REQUEST FOR A SEALED SOURCE OR DEVICE EVALUATION

RE: Envionics USA Chempro 100 Material License #45-23885-02E

A new application for registration of the Envionics USA Inc Chempro 100 was previously submitted and approved. We are requesting the following changes be incorporated into an amendment to the device registration. Except for the following changes, previous commitments for the Chempro and its distribution shall be honored by Envionics USA .

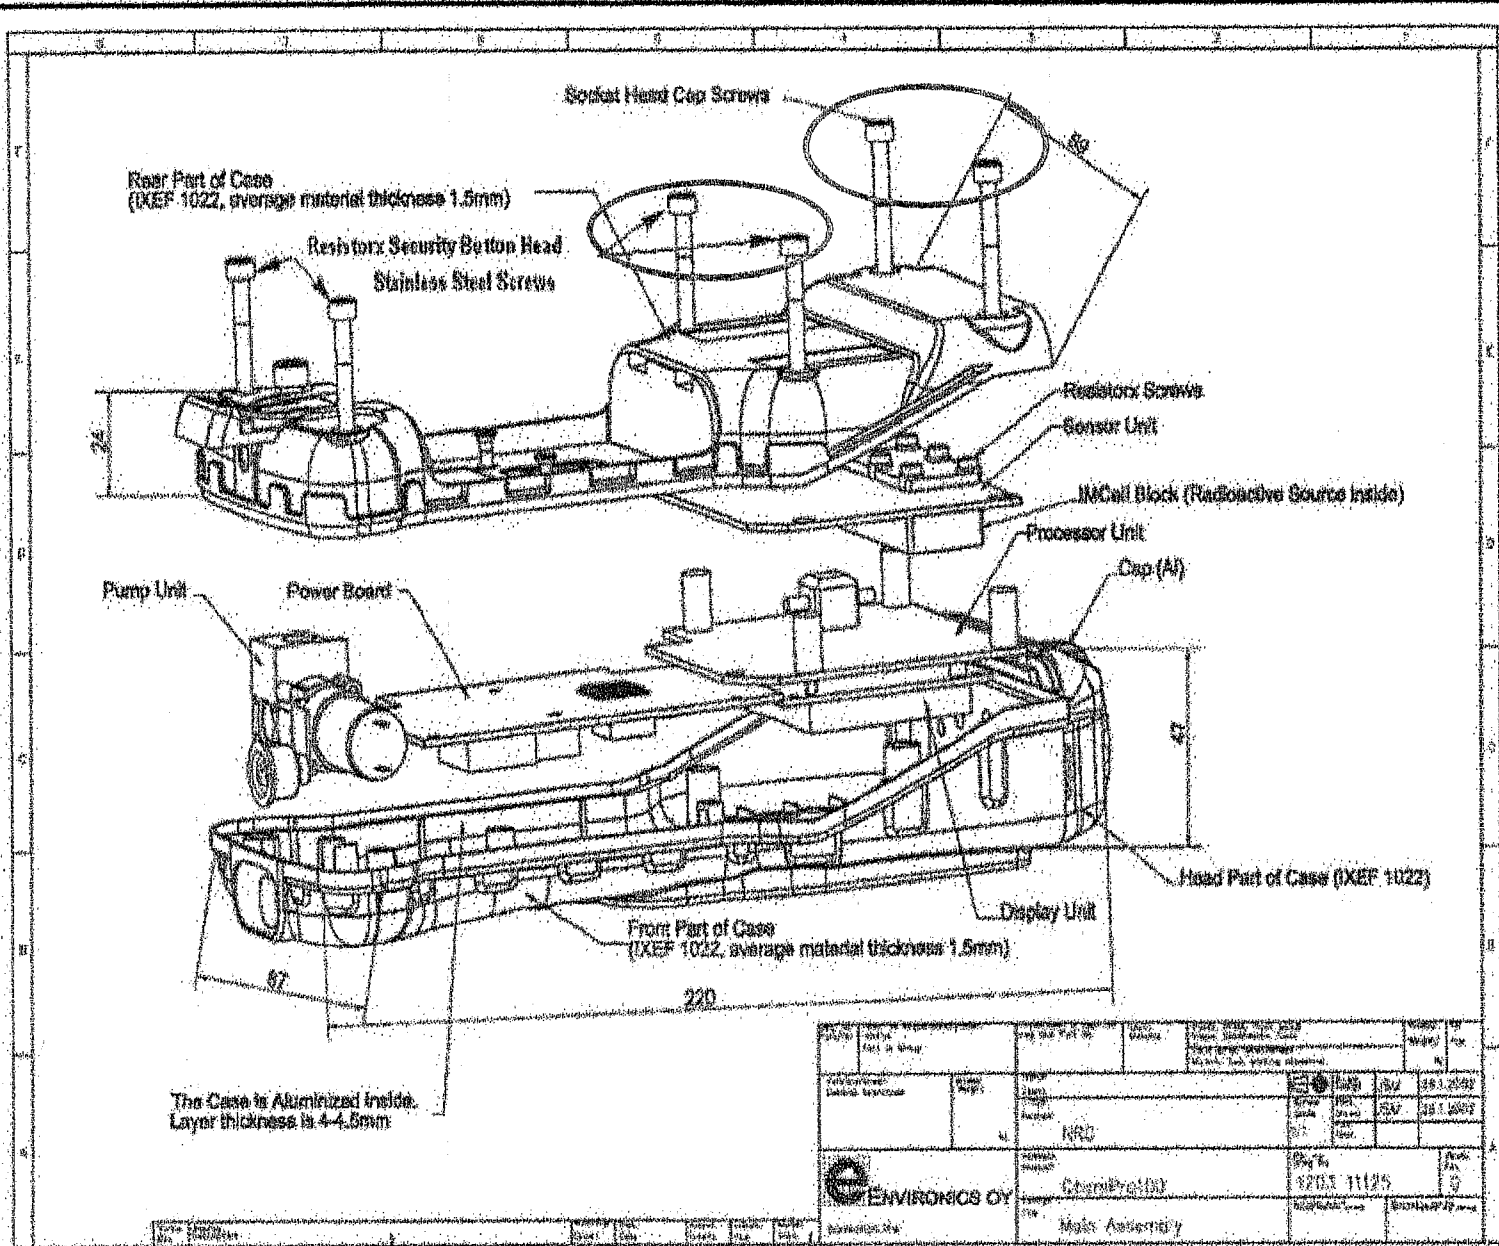
1. The phillips screws that are used to attach the belt clip will add the torx screw already used as an alternate part for producibility purposes; see attached drawing with the screws highlighted and spec sheet.
2. The label on the front marked Chempro will be removed to allow for branding of the device for specific markets (i.e. Drager MultiIMS for the Firefighters, etc.). See attached figure. All radiation labeling is unchanged. Specific labels will be added for the specific customer or market prior to shipment similar to the smoke detector market. This does not impact the safety or the operation of the device.
3. Add new facility located at 4420 Eastport Parkway, Port Orange, FL 32127 to block 12 of license as an additional distribution point.

Labels to be removed
